**IMPERIAL METALS CORPORATION
MT. POLLEY PROJECT**

**RESPONSE TO REVIEW COMMENTS
ON TAILINGS EMBANKMENT DESIGN
(REF. NO. 1625/6)**

JANUARY 25, 1996

FIGURE 1

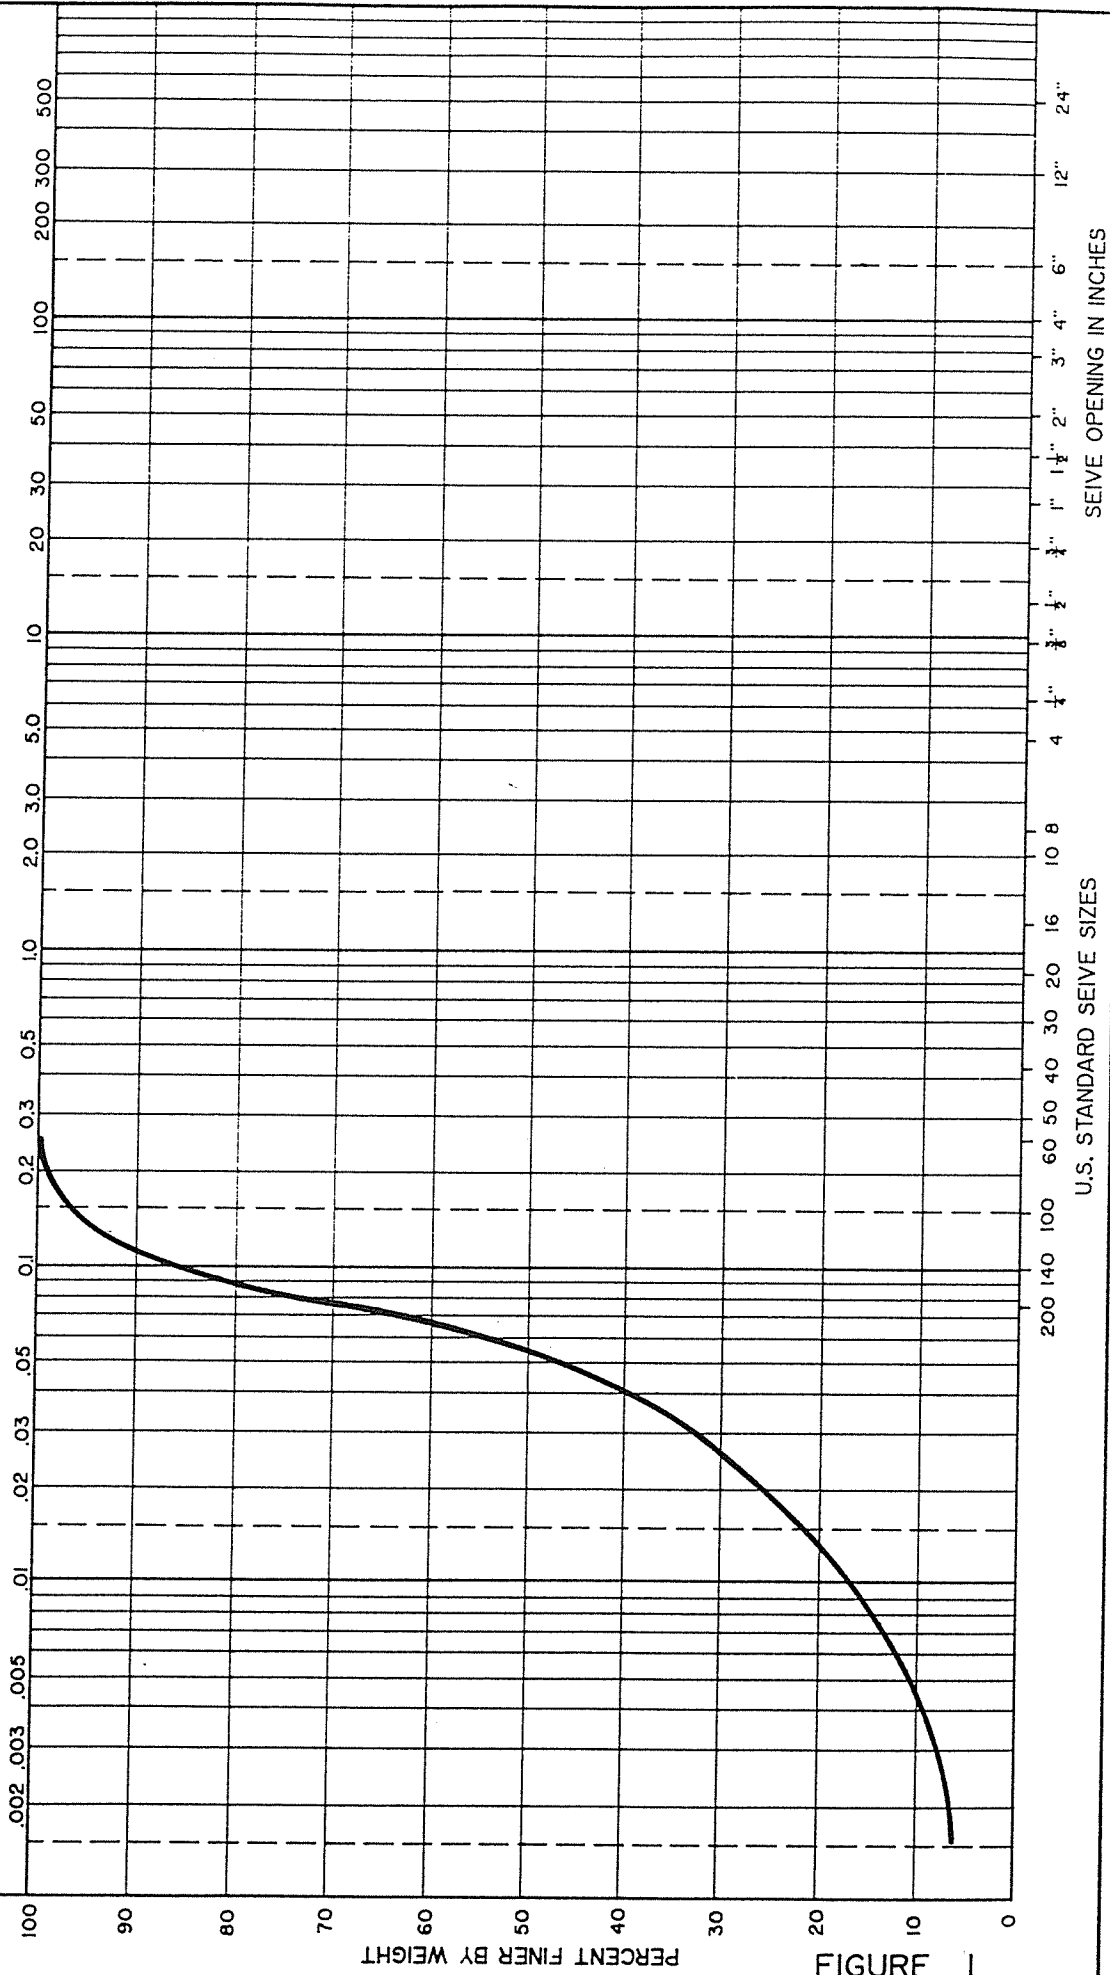
Filter gradation is required to be shown. The design must be conservative.

Filter gradations for construction materials are shown on Drawing No. 510-14-03-1625.212, which is taken from part of the Technical Specifications. The gradation of the tailings is shown on Figure 1 (from Tailings Storage Facility Design Report, Ref. No. 1625/1, May 26, 1995).

Index tests on the bulk tailings sample shown on Figure 1 indicate that the material is non-plastic and fine grained, with 6 percent clay, 64 percent silt and 30 percent fine sand. The operations of the tailings spigotting system will lead to some separation of the tailings adjacent to the embankment, whereby coarser materials will settle out rapidly and finer materials will be transported further out into the pond. The result is that additional filter relationships will be developed between the fine and coarse tailings as well as between the coarser tailings and embankment fill materials. In the event that cracks develop on the embankment from the upstream side, it is anticipated that the tailings will also function as a crack stopping filter medium.

FIGURE 2

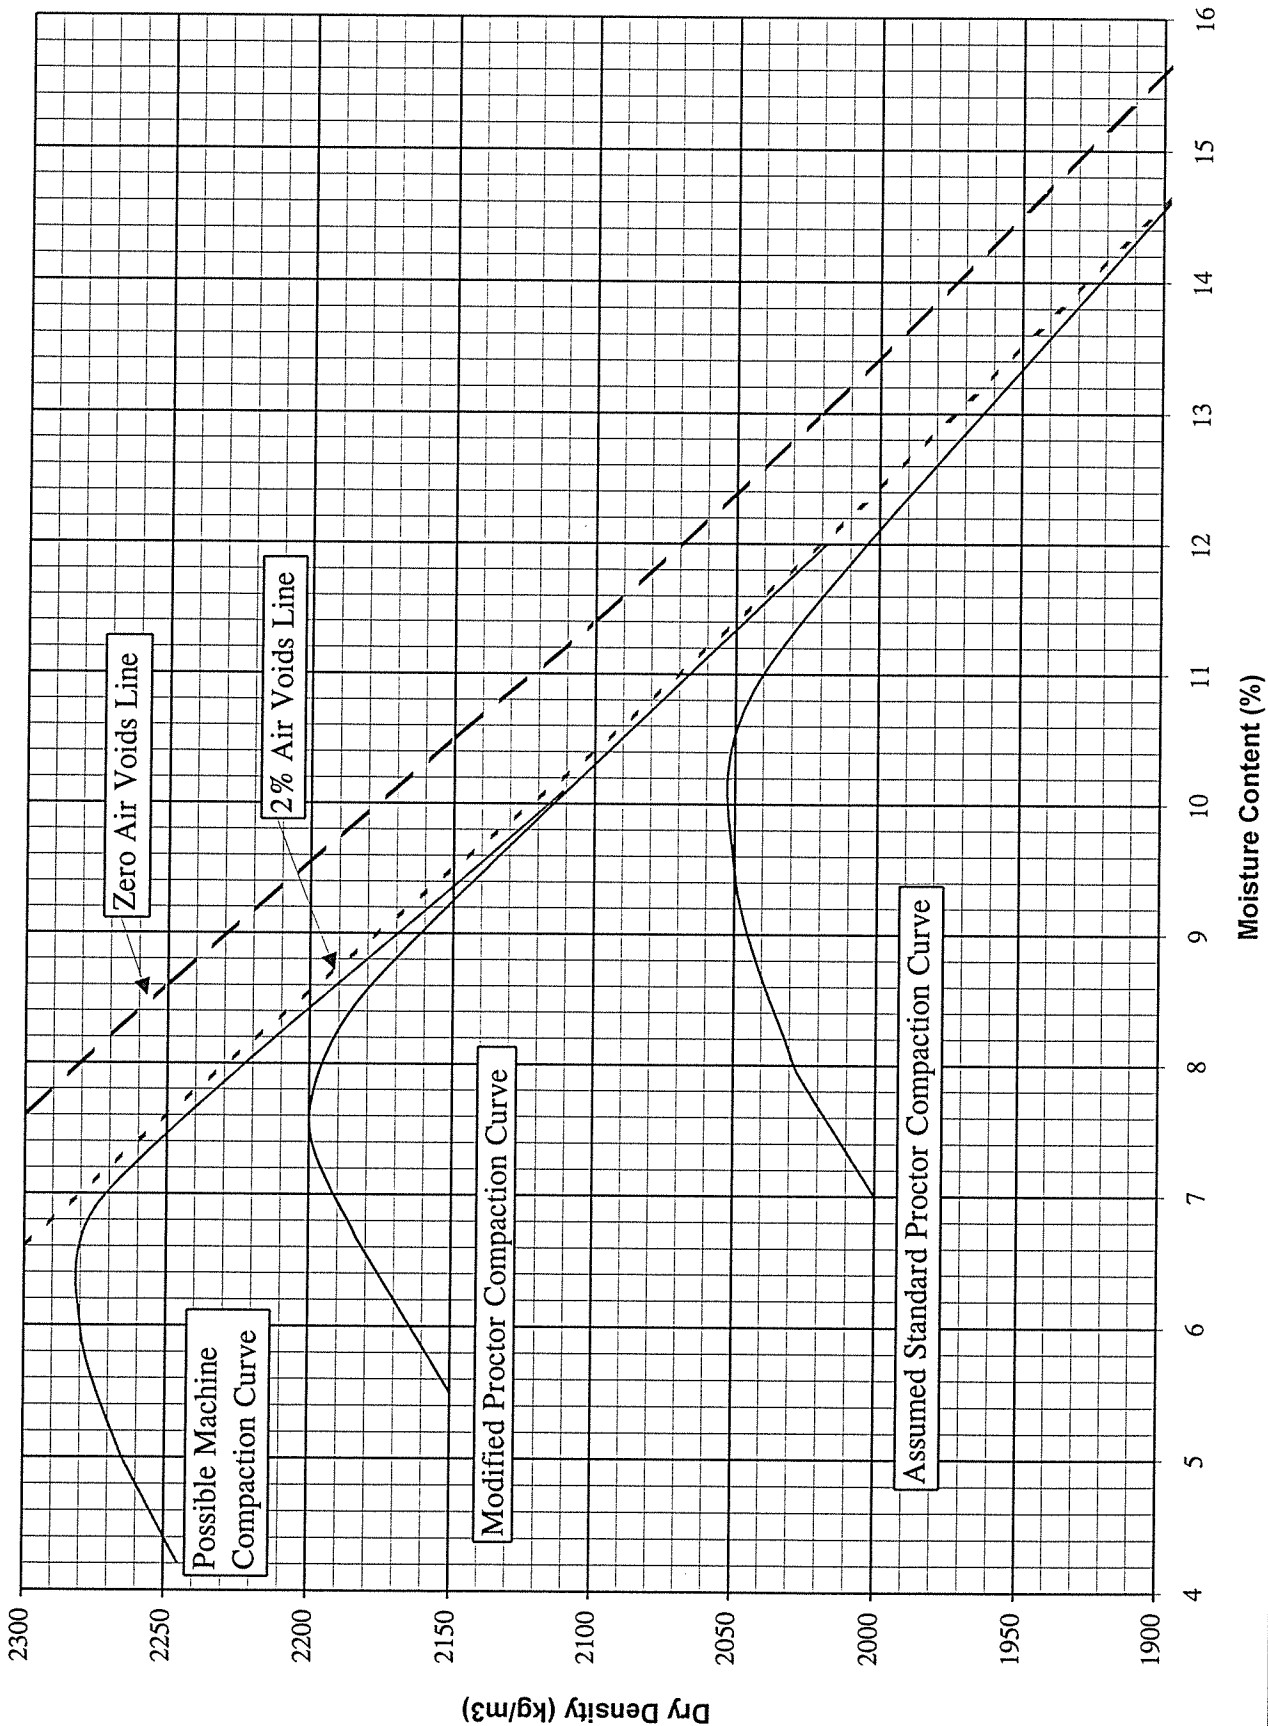
Why is Modified Proctor density used as the reference? Standard Proctor density is more common. A higher moisture content can be tolerated with Standard Proctor criteria. Over-compaction results in a brittle dam structure with limited flexibility to deal with differential settlement.

Mr. Brawner's statements reflect a common misconception within the earthworks construction industry. As indicated on Figure 1, there are different moisture-density relationships depending on the level of compactive effort applied. The Standard Proctor energy is lower than for the Modified Proctor test and, for the given example, the machine compaction energy is still higher.

It is evident from Figure 2 that if one only considers the individual test results, the 'maximum' density decreases as the compaction effort is reduced, and the 'optimum' moisture content also increases as the compactive effort is reduced. However, the theoretical moisture content - density relationship for a soil is defined by the zero air voids line, but we generally find that the 2% air voids line is usually the control in practice. Consequently, if the Standard Proctor moisture density criteria are

specified, a lower density fill with a higher permeability and greater compressibility can result. Also, if the contractor attempts to place the fill at the standard proctor optimum moisture content with the heavier compaction equipment, he will sometimes find that excessive rutting, weaving and pore pressure development (or moisture profiles) can occur in fine grained soils. Knight Piésold have therefore used the Modified Proctor test as the reference as it provides a moisture - density relationship which is closer to the relationship expected from the specified compaction equipment.

The glacial till has a fairly low plasticity ($PI = 10$ to 14) and will be placed at near the optimum moisture content as defined by the Modified Proctor test. Placement at a higher moisture content and a lower density as suggested by Mr. Brawner would result in larger post construction fill settlements and would increase the likelihood of cracks forming in the fill.
